## #00-02-35-003N: Clunking Noise Under Hood and Can Be Felt in Steering Wheel and/or Steering Column (Replace Upper Intermediate Steering Shaft (I-Shaft) Assembly) - (Mar 26, 2008)

**Models:** 2002-2006 Cadillac Escalade Models  
1999-2007 Chevrolet Silverado Models (Classic)  
2000-2006 Chevrolet Suburban, Tahoe Models  
2002-2006 Chevrolet Avalanche  
1999-2007 GMC Sierra Models (Classic)  
2000-2006 GMC Yukon, Yukon XL Models  
2003-2006 HUMMER H2

This bulletin is being revised to add diagnostic information (refer to Diagnostic Tips) to check the lower steering column bearing as a potential source of the noise. Please discard Corporate Bulletin Number 00-02-35-003M (Section 02 -- Steering).

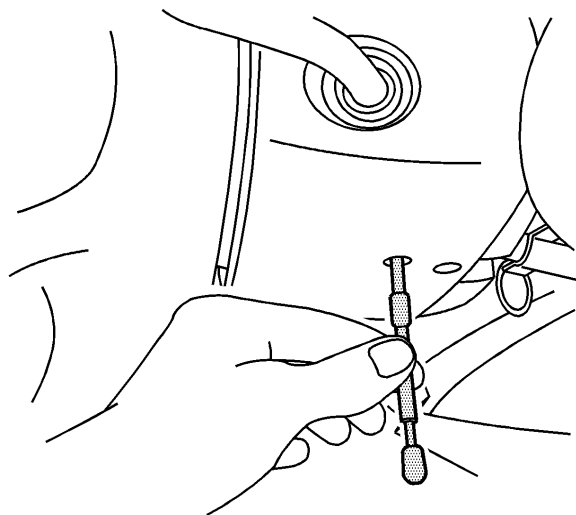
DO THIS	DON'T DO THIS
Replace the I-Shaft with P/N 19153614.	Do NOT lubricate or exercise the I-Shaft.

- I-shaft P/N 19153614 has been designed to replace previous designed dampened and non-dampened I-shafts. The physical difference in the yoke size will accommodate all vehicles listed in this bulletin.
- Due to the design of the new I-shaft, it is not possible to lubricate/grease the I-shaft.

Replace the steering column upper intermediate shaft with an improved design shaft that will eliminate the clunk noise using the procedure listed below.
